# WOLF CREEK

ET 99-0050

Subject: Docket No. 50-482: Proposed Revision to Technical  
Specification 3.5.5, Seal Injection Flow

Figure 3.5.5-1 (page 1 of 1)  
Seal Injection Flow Limits

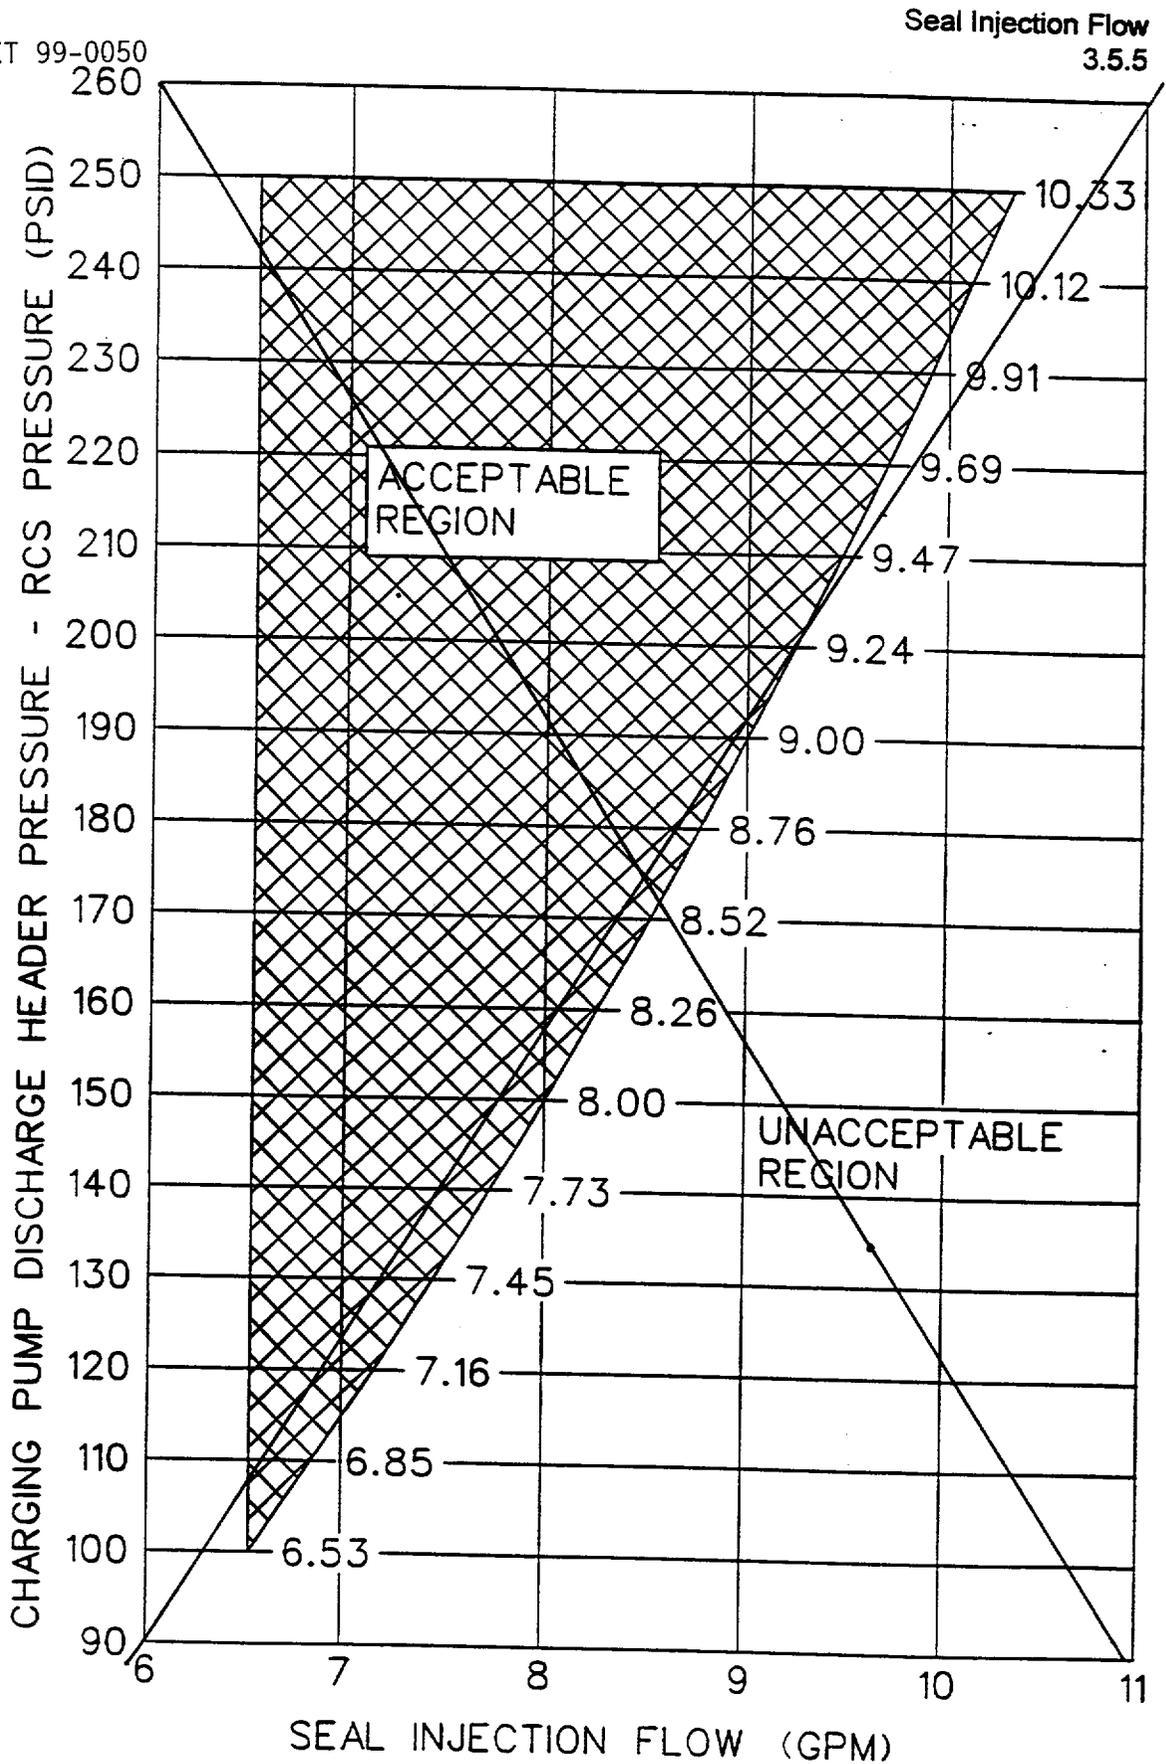
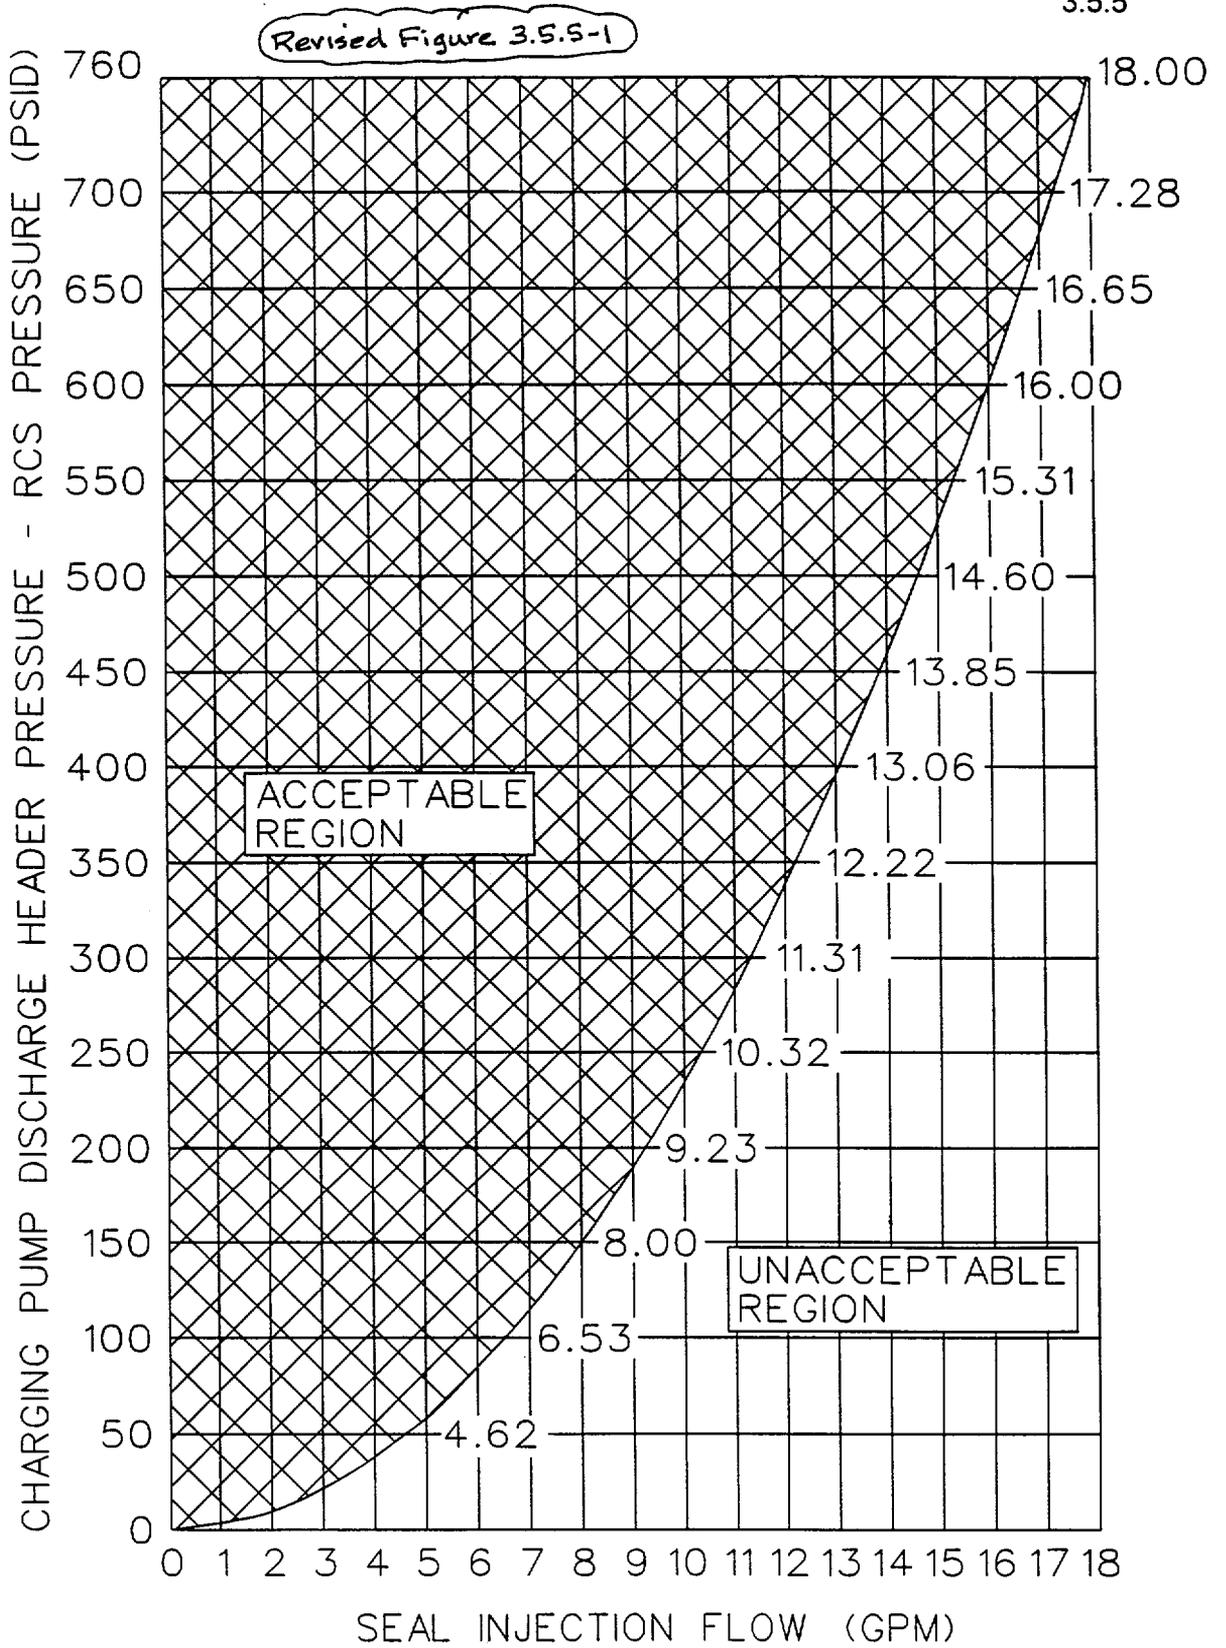
This license amendment request proposes to revise improved Technical Specification LCO 3.5.5, Figure 3.5.5-1 to provide flow limits that address normal and off-normal plant operating conditions. Specifically, the figure is being revised to reflect the flow limits at higher differential pressures and abnormally low seal injection flows.

The potential exists that during plant operation, a transient or equipment failure could occur that would result in the seal injection flow being outside the Acceptable Region of the currently approved Figure 3.5.5-1. This transient or equipment failure could be unrelated to the position of the seal injection throttle valves such that adjustment of the valves would not result in being in the Acceptable Range of Figure 3.5.5-1. However, LCO 3.5.5 would still have to be considered not met and adjusting the injection throttle valves per Required Action A.1 may not restore injection flow within the 4 hour Completion Time. If adjustment of the throttle valves did not restore injection flow to within limits, a plant shutdown would be required per Required Action B.1.

The proposed change to Figure 3.5.5-1 extends the bounds of the figure to encompass the entire range of acceptable seal injection flow, while still providing the minimum ECCS flow assumed in the safety analysis. The proposed change to Figure 3.5.5-1 considers abnormally low seal injection flows. The normal operating range of injection flow is 8 to 13 gpm per RCP. In the event that seal injection flow is less than 6 gpm per pump, procedure OFN BB-005, "RCP Malfunction," provides the necessary actions for restoration of injection flow. This low flow rate is not significant to safety because the RCP thermal barriers provide sufficient cooling to the pump water bearing and shaft seal package when seal injection is lost. The upper portion of Figure 3.5.5-1 is also expanded to depict the flow limit at higher differential pressure which potentially could be observed at low reactor pressure in the presence of equipment malfunctions or LOCAs. The upper flow limit envelopes the maximum expected differential pressure during a large break LOCA. The upper flow limit of 18 gpm per RCP provides a conservative limit of 72 gpm total seal injection flow. This is conservative since the flow balance performed to simulate the LOCA condition with single train operation allows up to 80 gpm. The upper limits of allowable seal injection flow were not changed. The range of flow and differential pressure is expanded to encompass varying operational characteristics.

The proposed change to Figure 3.5.5-1 are within the bounds of the analyses. With the seal injection flow within the Acceptable Range of the revised figure, the LCO will still ensure that seal injection flow will be sufficient for RCP seal integrity but limited so that the ECCS trains will be capable of delivering sufficient water to match boiloff rates soon enough to minimize uncovering of the core following a large LOCA. The LCO also ensures that the centrifugal charging pumps alone deliver sufficient flow for a small LOCA and sufficient boron to maintain the core subcritical. For smaller LOCAs, the charging pumps alone deliver sufficient flow to overcome the loss and maintain RCS inventory.

This figure is constructed from the equation  $Q = \sqrt{0.4264 * DP}$  where  $Q$  = seal injection flow in gpm, and  $DP$  = charging pump discharge header minus RCS pressure in units of psid. The constant inside the square root is a function of pipe size, throttle valve resistance (position), and fluid density.
